Date: March 11, 2022
File No. 82725-109-MX

ADDENDUM No. 3

PROJECT: New Municipal Complex Contract B – Building Construction

1
A-1
FOUNDATION PLAN
BOROUGH BUILDING
SCALE: 1/8"=1'-0"

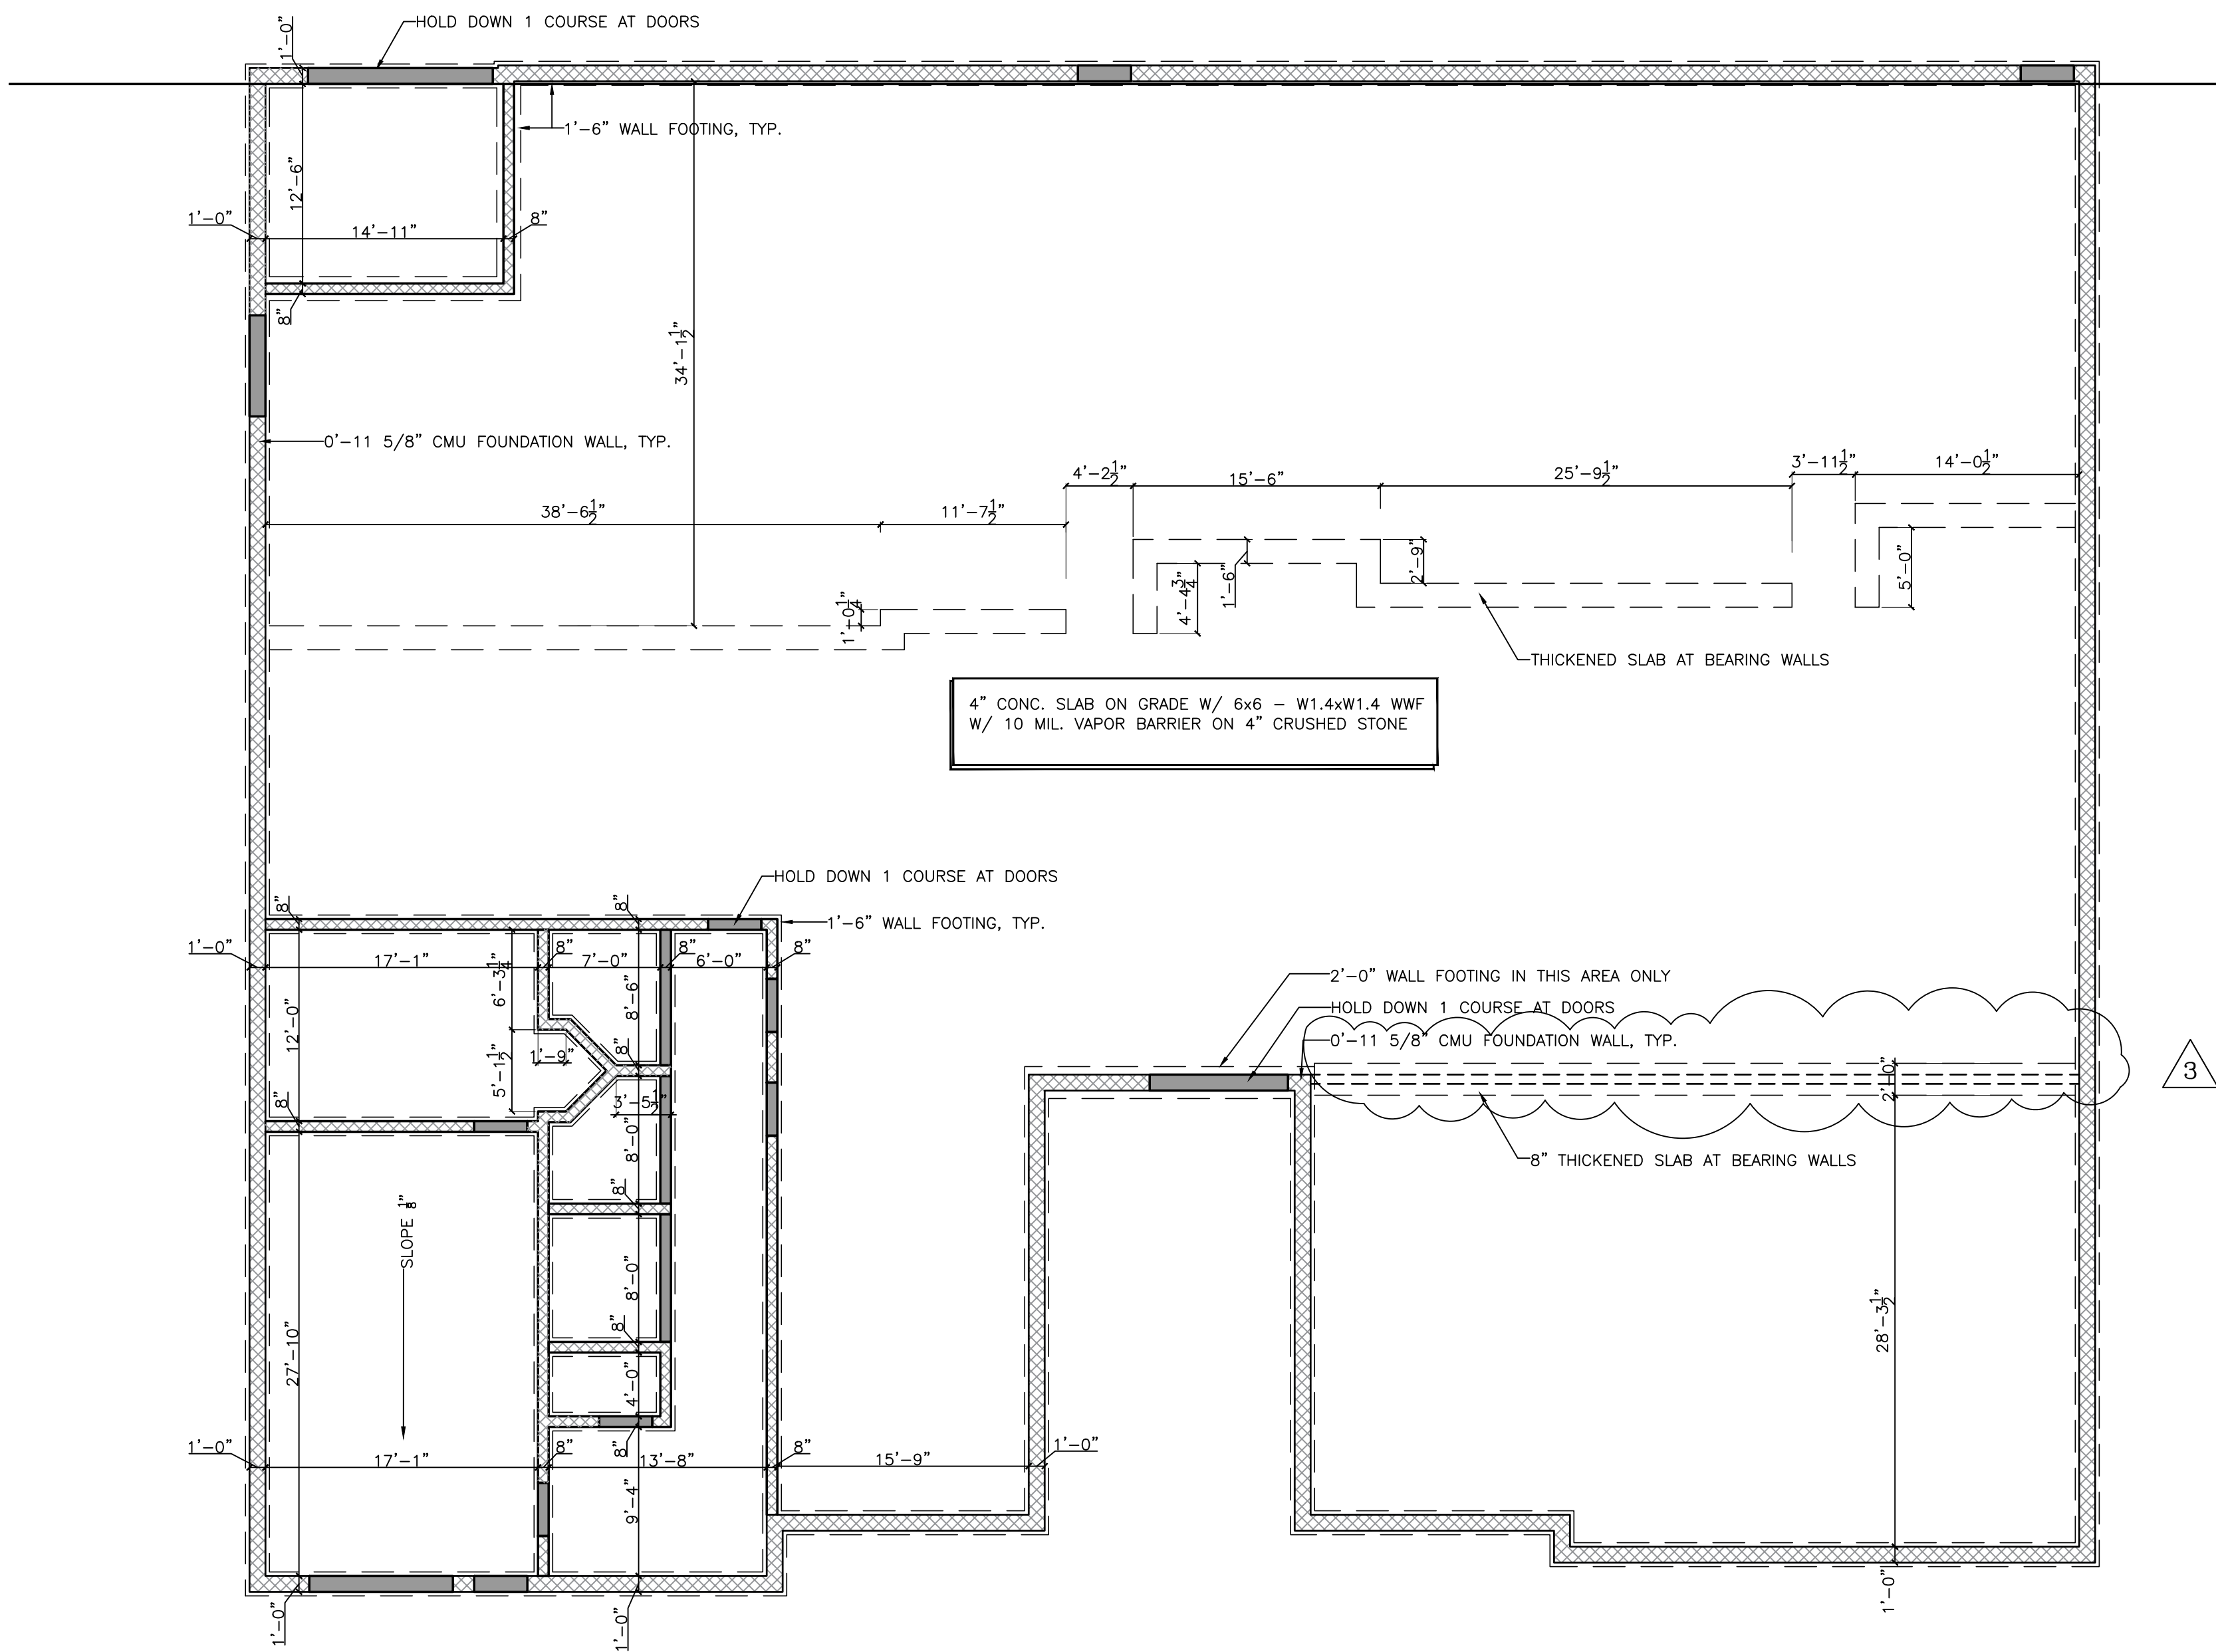
Since we already have walls with footings @ the sally port and holding cells these will be used as bearing to allow the girder truss to work. On the right side we will need to modify the wall @ council chambers to be a 2x6 wall and add an 8" thickened slab @ this wall to make it a bearing wall and eliminate the girder truss all together. Modified drawings have been issued show these changes.

NO.	REVISIONS DESCRIPTION	DATE
1	ISSUED FOR BID	2/28/20
2	ISSUE FOR PERMIT	6/25/20
3	ADDITIONAL LOAD BEARING WALL	3/11/22
